## Service Information Bulletin

SUBJECT	DATE
SPN 3599/FMI 3 and 4 (ACM)	May 2014

### Additions, Revisions, or Updates

## 2 SPN 3599/FMI 3 - EPA10

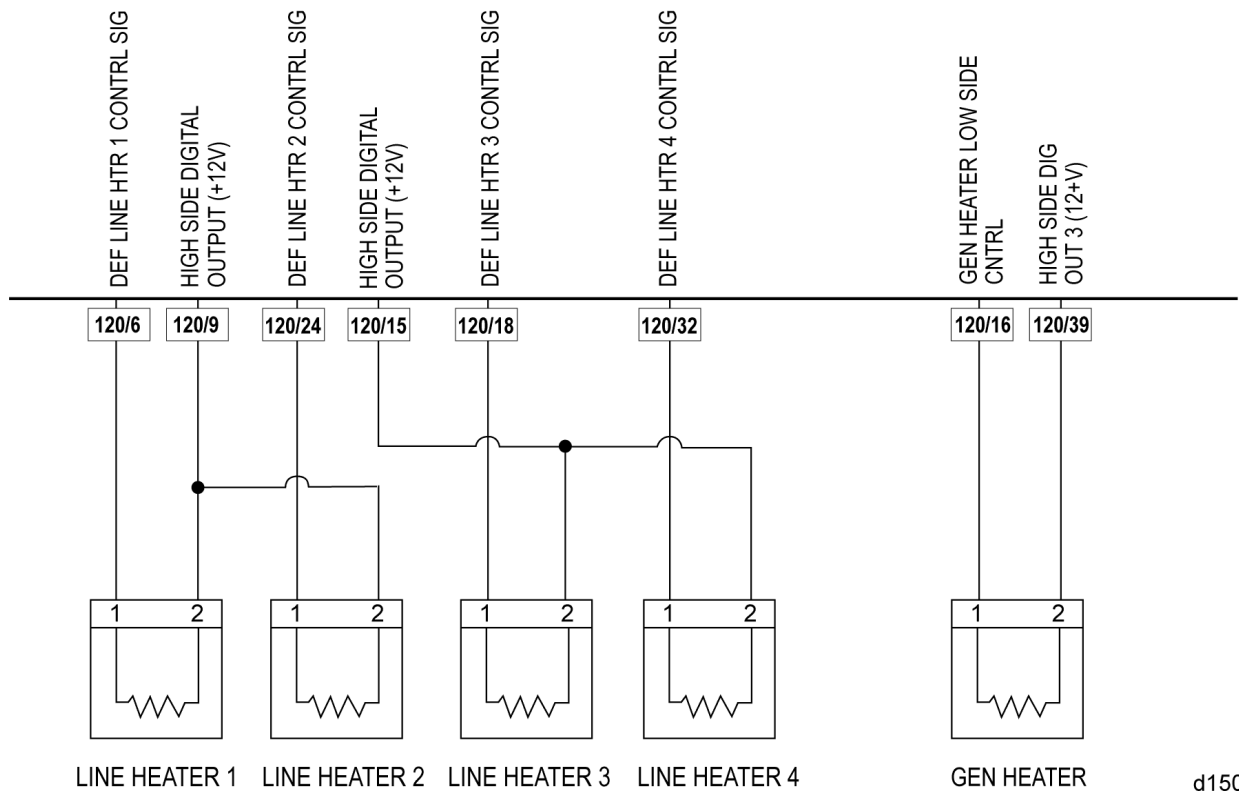
Publication Number / Title	Platform	Section Title	Change
DDC-SVC-MAN-0084	EPA10/ GHG14 DD Platform	SPN 3599/FMI 3 - ÖÜœ€	Corrections have been made to the diagnostic procedures. The procedures have also been separated by year due to power supply to different components. Wiring diagrams have been added.
		SPN 3599/FMI 3 - ÖPÖ1I	
		SPN 3599/FMI 4 - ÖÜœ€	
		SPN 3599/FMI 4 - GHG14

1. Disconnect the 120-pin ACM connector. Go to step 2.
2. Connect DiagnosticLink™. Go to step 3.
3. Turn the ignition ON (key ON, engine OFF). Go to step 4.
4. Does code SPN 3599/FMI 3 still set?
  - a. Yes; replace the ACM and Refer to section "Removal of the Aftertreatment Control Module". Verify repair.

- b. No; turn the ignition OFF. Refer to OEM literature and repair the wire between the ACM and the line heaters/  
general heater in the dosing unit. Verify repair.
